PROPOSED REDEVELOPMENT OF BURBIDGE SITE.

Thank you for inviting me to accompany you and your colleague on a visit to Burbidge's site – it was a most interesting morning. In the light of what we saw, I now write with some corrections to my letter objecting to Listed Buildings Consent application 09/15870/LBC, and some further descriptions and comments.

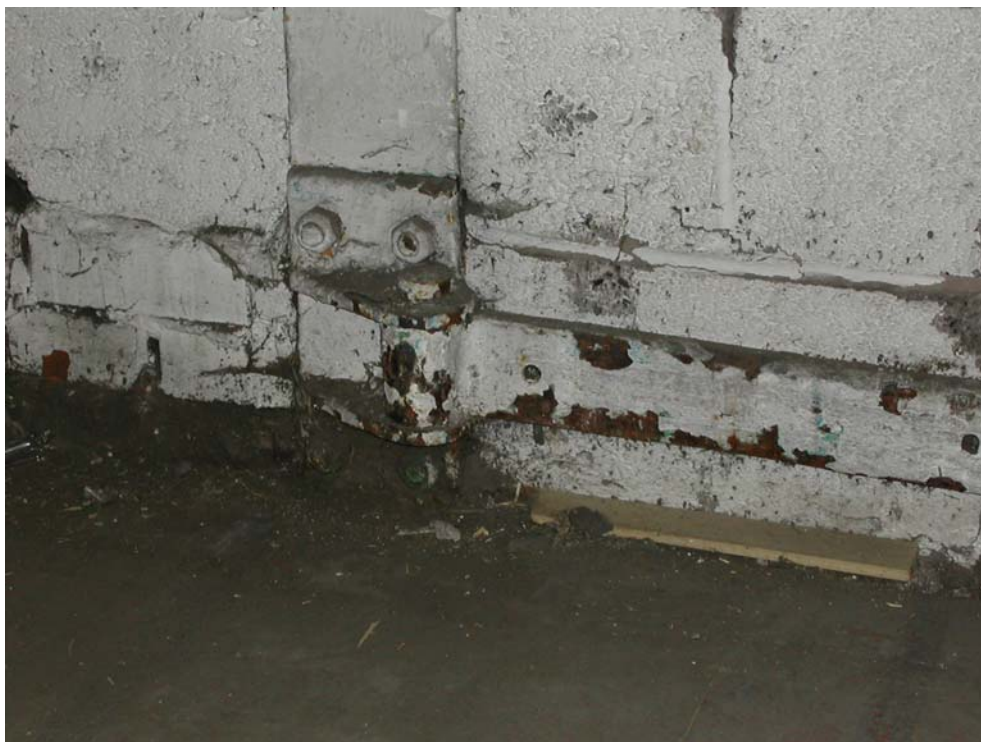
A stanchion between bays 1 and 2. The Glengarnock Steel Co. Ltd. was trading from 1890 to 1915, the works being taken over by Colvilles Ltd. then British Steel.

An original bottom hinge to a blocked-up door opening, bay 1.

Half-trusses at hipped end of bay 1

Half-truss and braced principle rafters at hipped end of bay 1.

Loco shed window opening and eaves corbelling from outside (left) and inside (right).

1939 roof trusses of loco shed.

South-west end of loco shed, as altered for 1939 re-roofing (and again recently?), showing unpainted brick pier.

North-east end of loco shed, showing original openings adapted for lorry loading, and battered plinth.
